Wallarrah 2 Coal Mine – Amendment to Development Application SSD-4974 (the amended DA) lodged for the Wyong Areas Coal Joint Venture (WACJV) on 7 July 2016

Please find attached Darkinjung LALC's comments and objections to the above amended Development Application.

2. This submission is Darkinjung's response to the Wallarah 2 Coal Project - Amendment to Development Application SSD-4974 (**the Amended DA**) lodged for the Wyong Areas Coal Joint Venture (**WACJV**) on 7 July 2016.

Fig 1.2 Distance between Coal Loader and Darkinjung's Residential Development

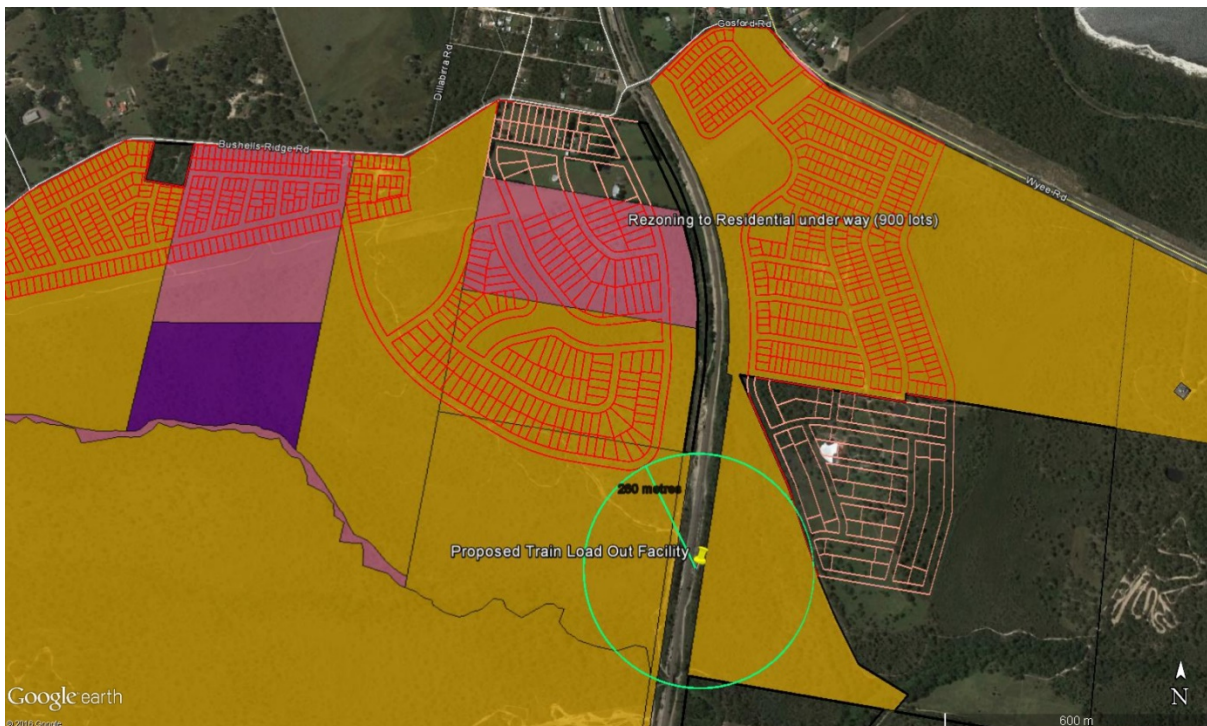
- (a) The proposal to put mine infrastructure on Nikko Rd, and the proposal to close Nikko Rd will deprive Darkinjung of the only existing practical legal access to its land. The proposed removal of the existing road reserve will limit Darkinjung's use of its land into perpetuity.
- (b) The 3m access easement put forward as an alternative is ill-conceived, insufficient, dangerous and impractical.
- (c) The Amended DA proposes to place mine infrastructure immediately adjacent to Darkinjung's land with no buffer or set back.
- (d) The Amended DA places the mine infrastructure in close vicinity to other land which is the subject of a Gateway Determination was subsequently issued for Darkinjung Sites 3 & 4 – approximately 900 residential lots. The proposal will impact on that development.

24. Furthermore, in relation to the visual impact, the Amended DA fails to accurately represent the significant industrial shed (transfer station) adjacent to the Motorway Link Road or the 27m high (8-9 storeys) coal loading facility which is approximately 262m from Darkinjung's proposed developments.

Fig. 1.3 Detail required for continued access under Link Road overpass – provided by Wallarah 2 Coal Project on 29 August 2016 (not included in amended Development Application)

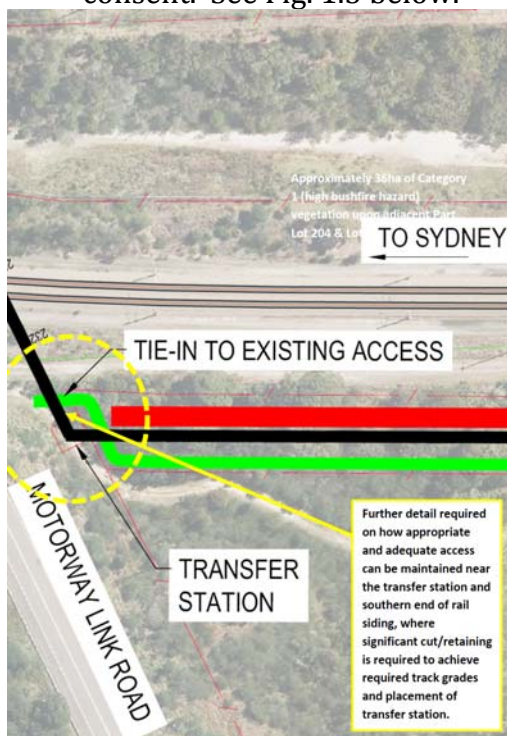
39. Of particular concern to Darkinjung is that the Amended DA is premised on the closure of Nikko Rd. Nikko Rd is a formed dirt road that fronts Lots 60, 196, 197 and 204. It is the only road access to those parcels.
40. Nikko Rd is a Crown Road and the public currently have a right to access it.¹⁰ Darkinjung is currently able to access Nikko Rd through Lot 1 DP 1192889, Bushells Ridge. Darkinjung accesses Lots 196 and 197 as part of its use and enjoyment of the land as well as to comply with environmental monitoring requirements imposed by the WSC as a condition of separate development consent. See Fig. 1.3 below.

Fig. 1.6 Wyong to Wyee Development Corridor – showing Nikko Road link

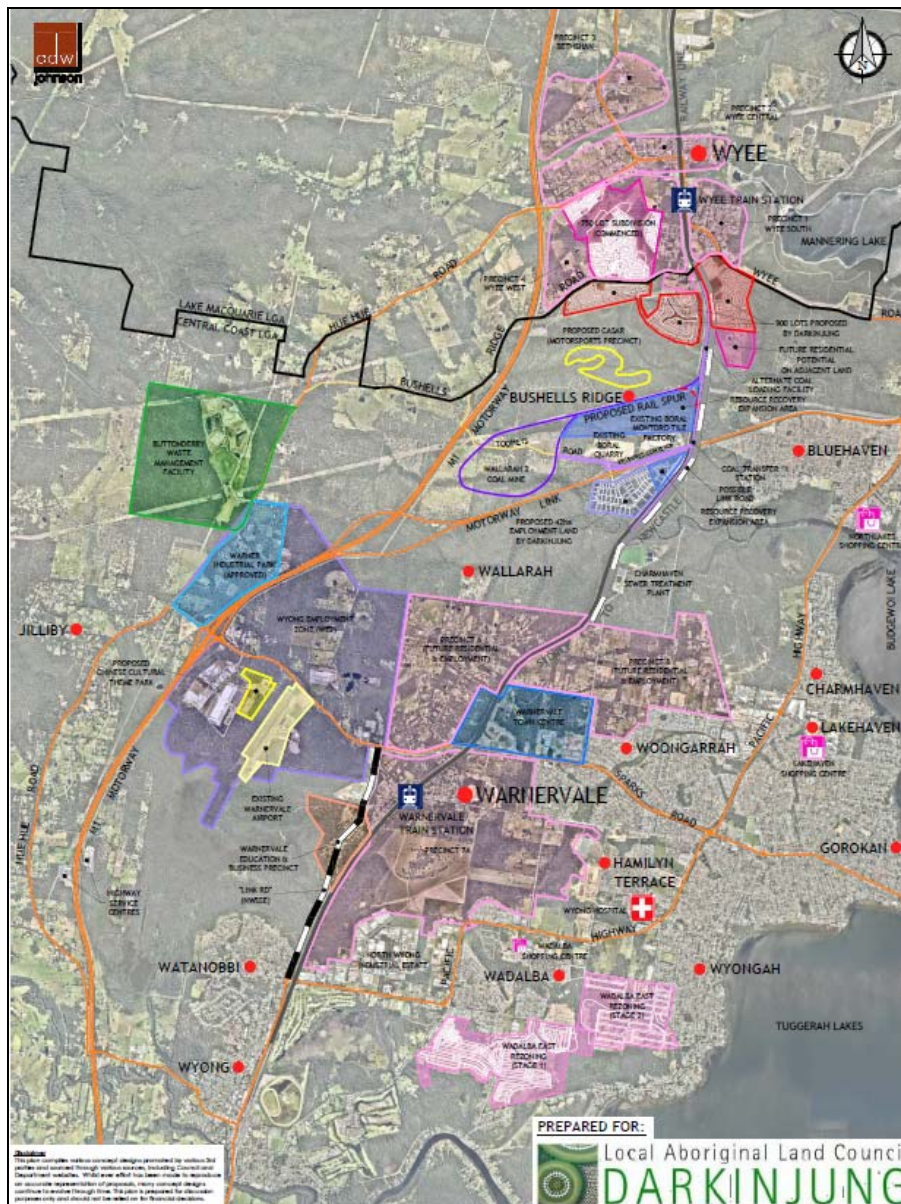
46. Nikko Rd is also a strategically important part of the road network in the Wyee / Warner Vale area. As noted above, Wyee and Warnervale have been identified as residential growth areas. Darkinjung's involvement with the NSW Government inter-agency taskforce has led to the potential development of the Wyee Road Residential Site and the Bushells Ridge Residential Site through the Gateway Process. Fig. 1.6 shows the proposed growth of both centres and the clear linkage known as Nikko Road.
47. When those areas are developed, Nikko Rd would have the potential to provide an important road corridor which would allow movement of traffic between Wyee and Warnervale without the need for residents to enter on to the express way. If this proposal proceeds the linkage of Nikko Road will be lost.

Fig 1.8 – Property access road requirements (rural areas)

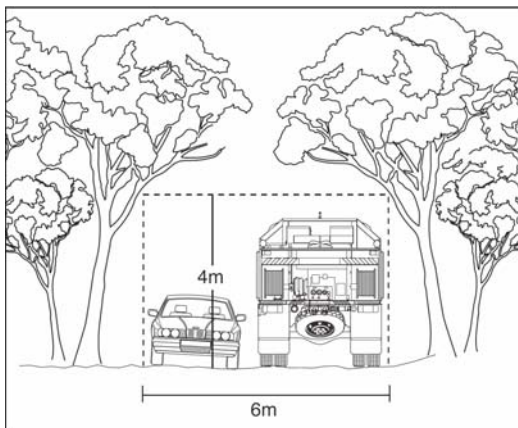
- (h) The easement is inadequate for a road which comprises bushfire prone land (vegetation buffer). It does not provide adequate access, let alone a safe turn around area. For example a standard Isuzu FTS750 Crew Cab Tanker Class 1 4 x 4 which is used by Fire and Rescue NSW has a 2.5m width which leaves just 25cm on either side to stay within the easement let alone room to access and use equipment stored on the sides. It has a width of 2.5m and a turning circle of 17m. The Isuzu FTR 800 4 x 2 has a turning circle of 16m. A 3m wide access road with a retaining wall on one side and a fence or coal load facility on the other side is not a defensible space for emergency services. It does not provide sufficient width to allow firefighting vehicle crews to work with firefighting equipment about the vehicle.
